CSP 24-058KB (BP027) – ADDENDUM No.02 RESTROOM RENOVATIONS

Fort Bend Independent School District 2023 Bond Program

Addendum Summary

Addendum: 002

○ ISSUE FOR BID 1 04.30.2024 ISSUE FOR BID 2	AND PERMIT
Date of issue: 04.30.202	
2023 BOND PROGRAM - BP027 - CSP 24-058KB - HUNTERS GLEN ELEMENTARY	695 Independence Blvd Missouri City, 77489
ENLARGED I PLANS	DEMO
JOB 23383.0 DATE 04.30.20 SHEET HG-A0C)24

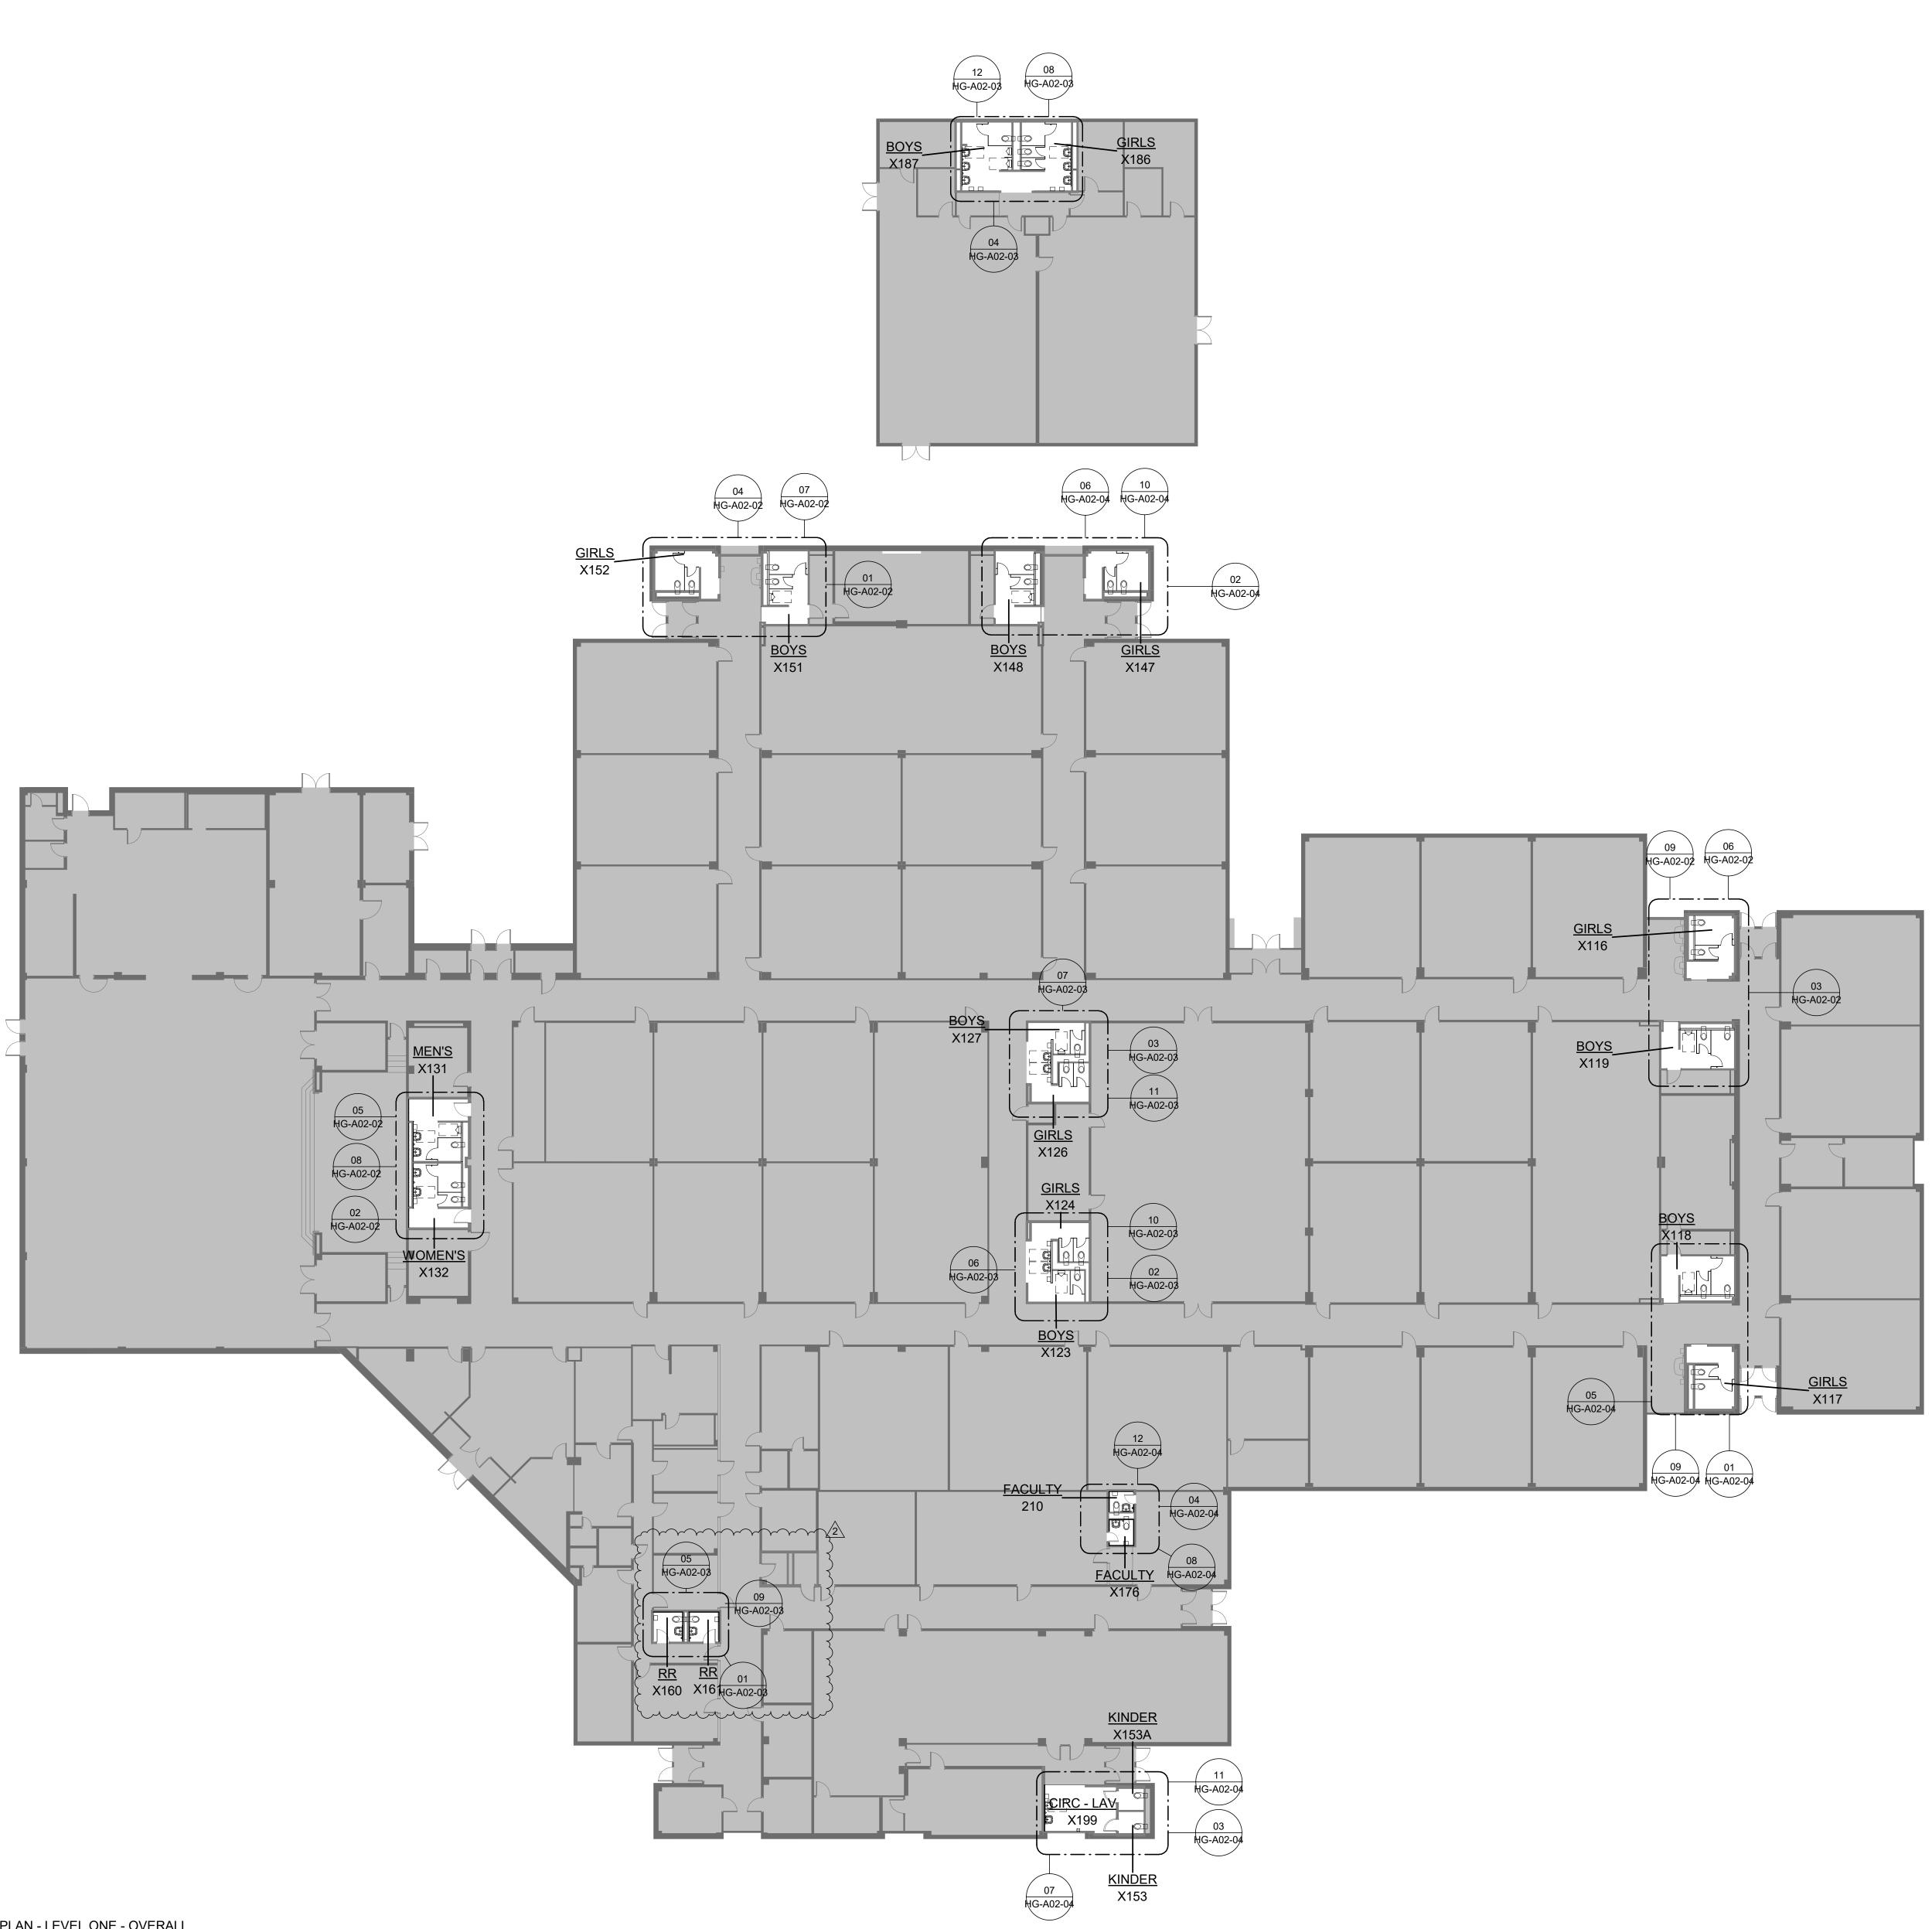
- Sheet HG-A00-01: Detail tags and scope of work at restrooms X200 and X201 are changed to restrooms X160 and X161.
- Sheet HG-A00-2: Details 08 and 10 are modified to change scope of work to match restrooms X160 and X161.
- Sheet HG-A02-01: Detail tags and scope of work at restrooms X200 and X201 are changed to restrooms X160 and X161.
- Sheet HG-A02-03: Details 01, 05, and 09 are modified to change scope of work to match restrooms X160 and X161.

HG-P31-01

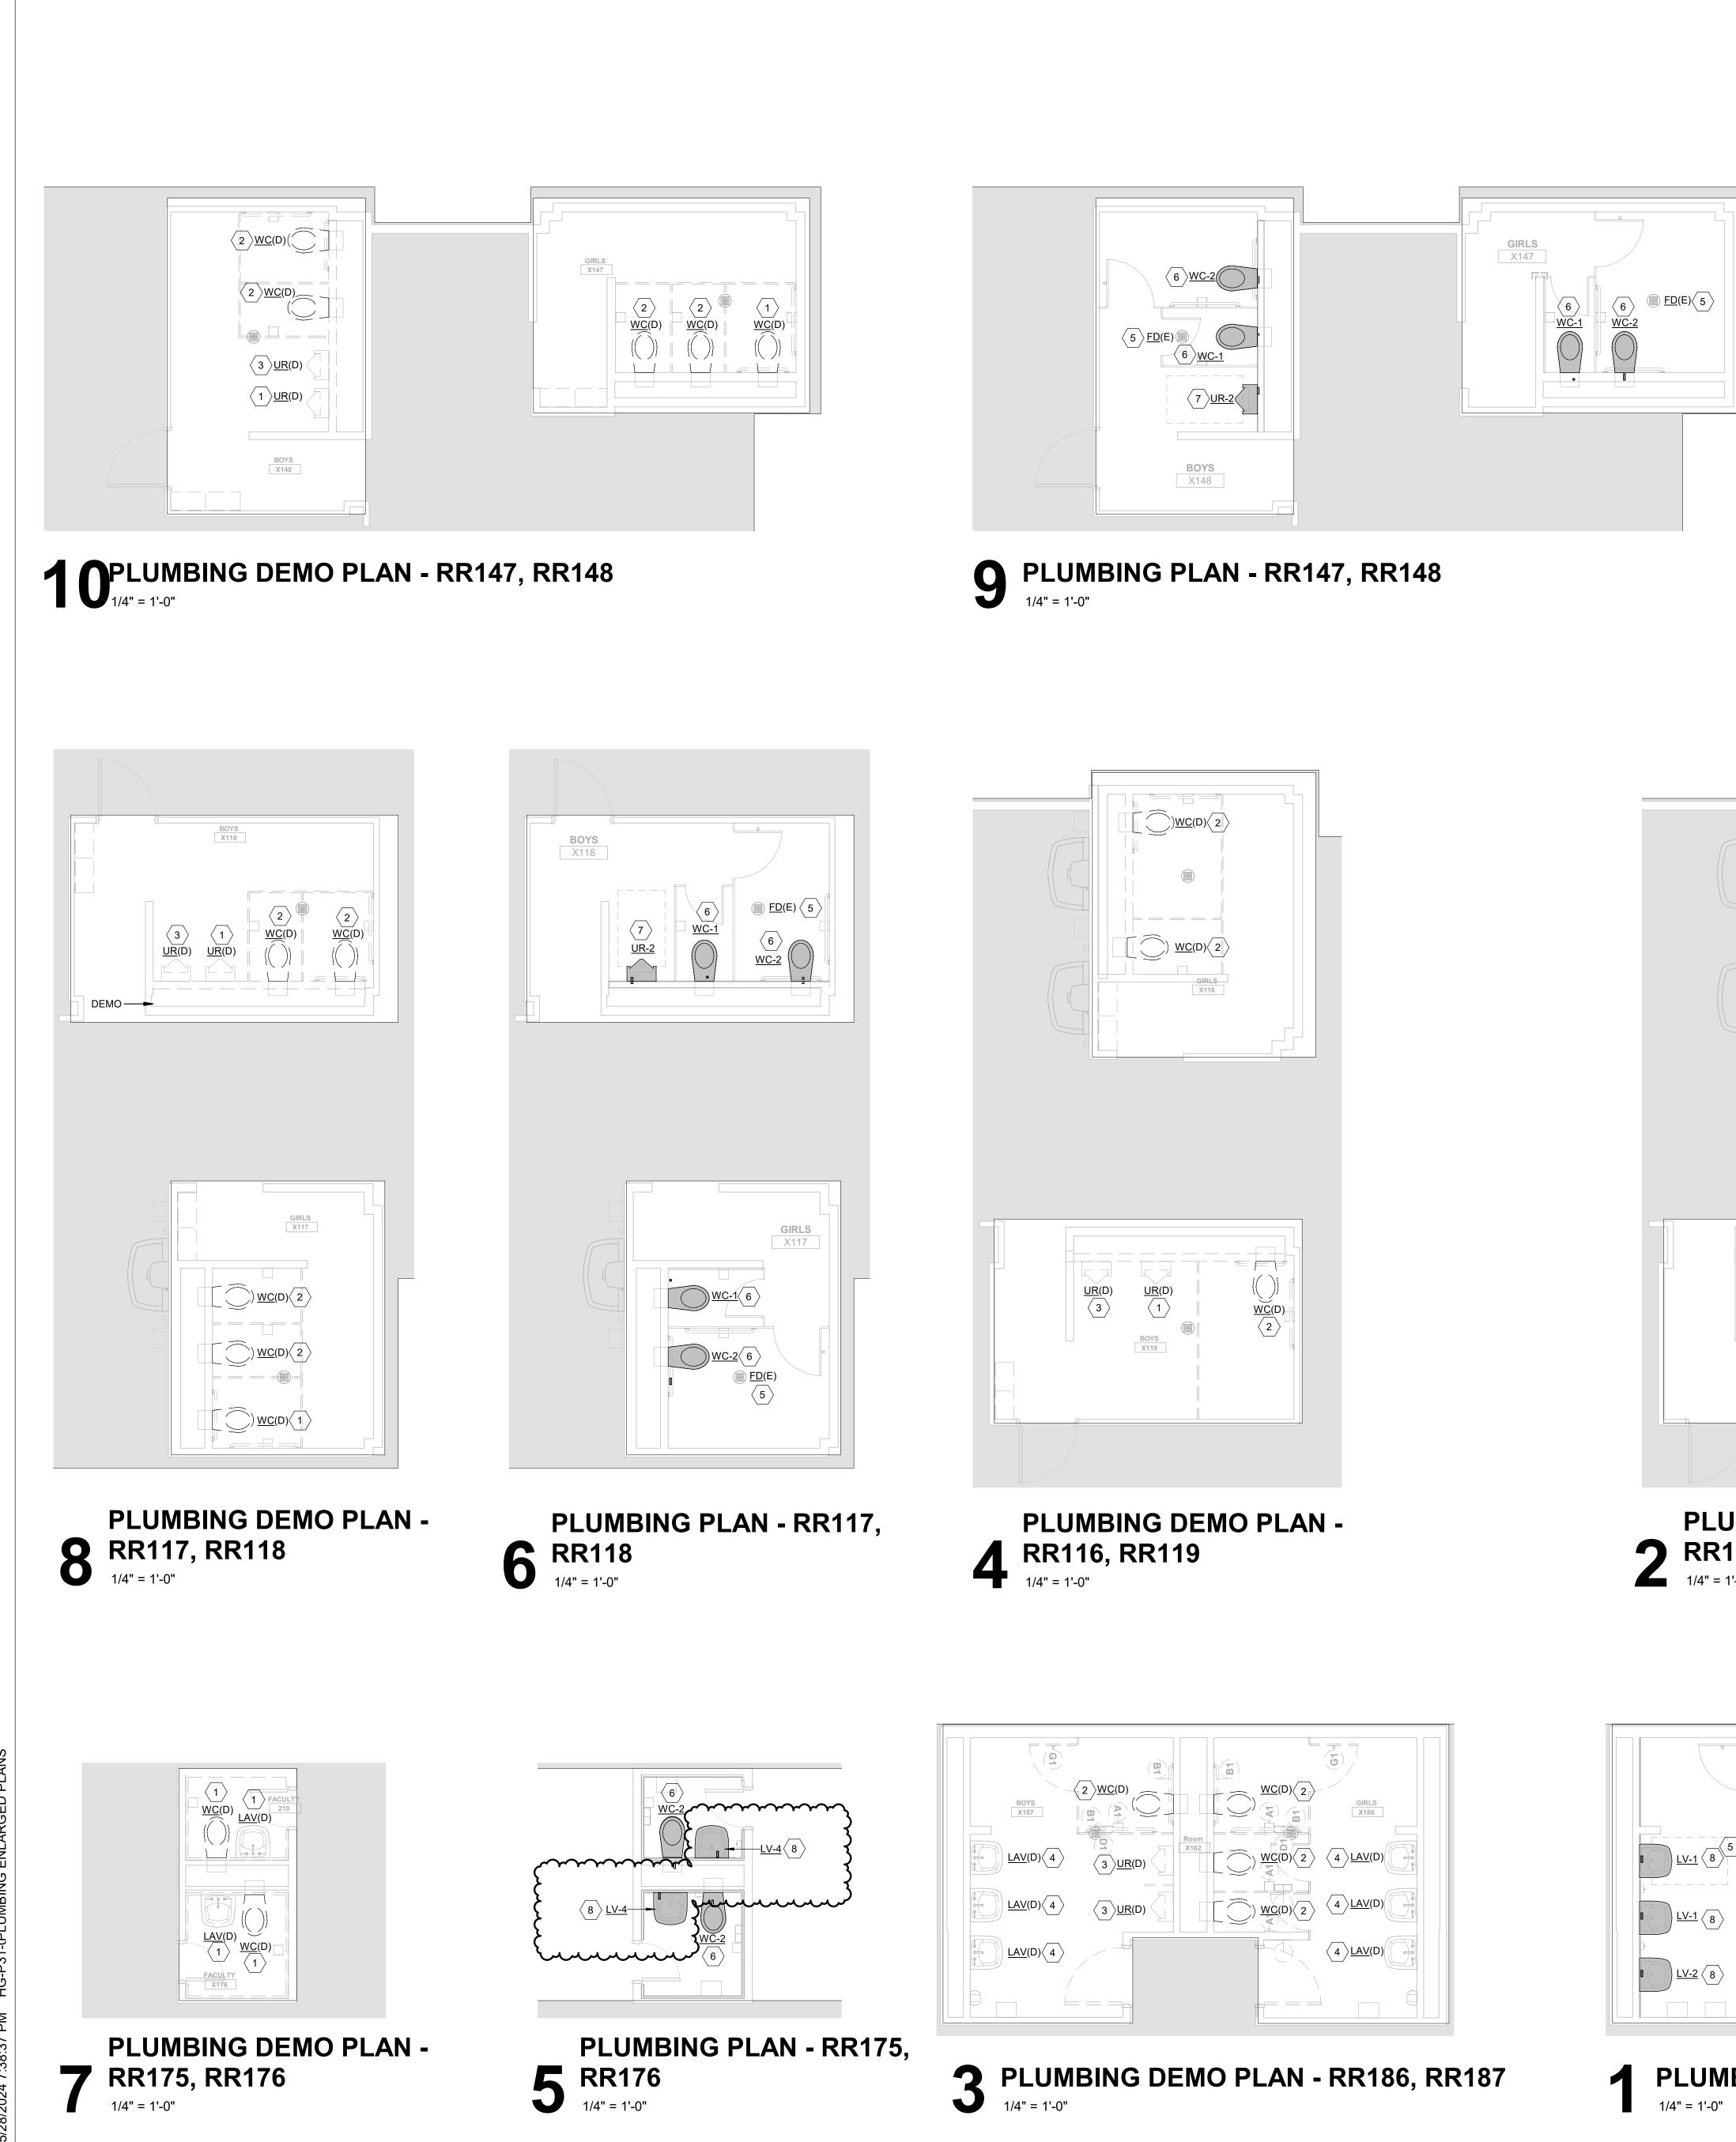
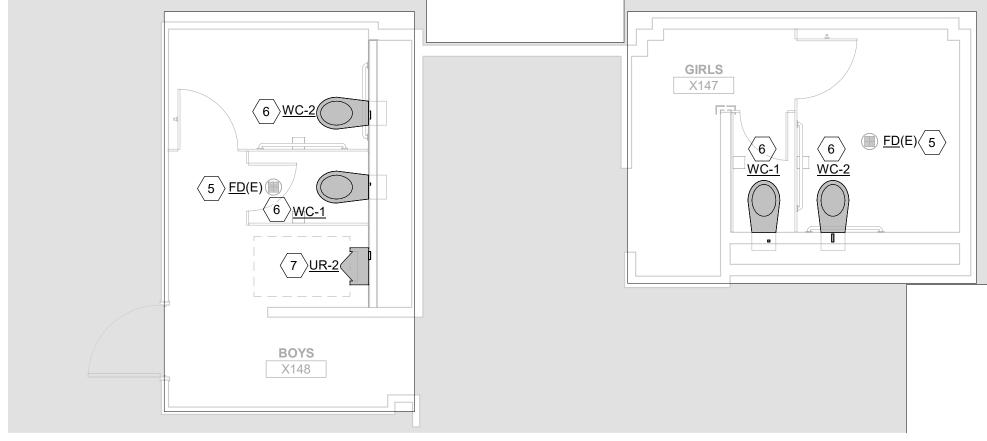
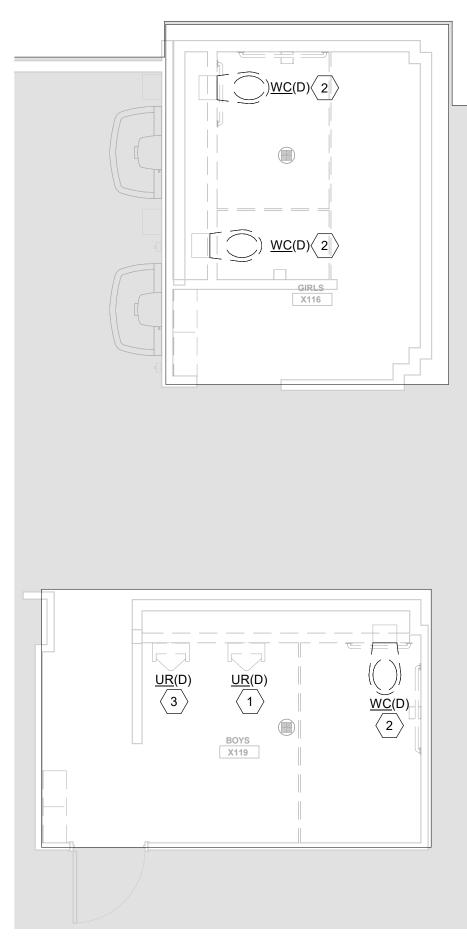
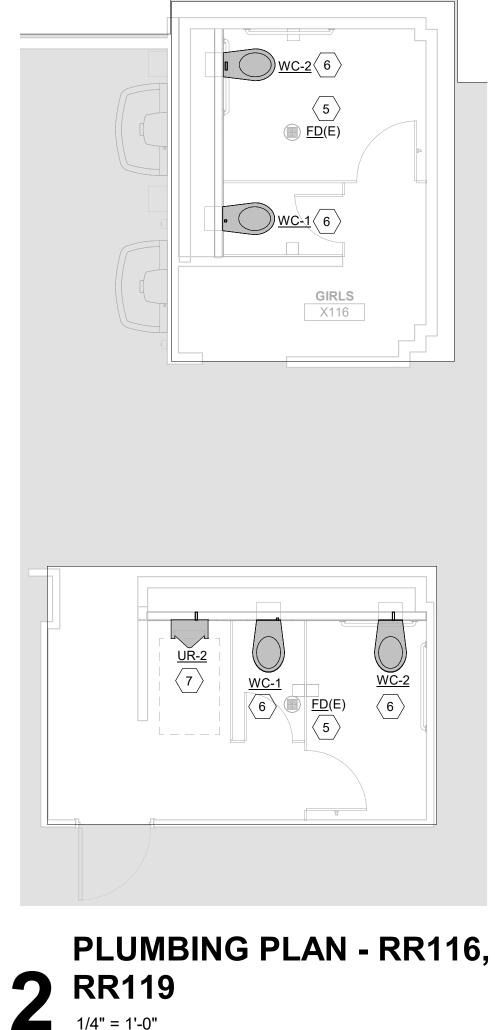
- Sheet HG-P20-01: Detail tags and scope of work at restrooms X200 and X201 are changed to restrooms X160 and X161.
 - Sheet HG-P31-01: Details 8 and 10 are modified to change scope of work to match restrooms X160 and X161.
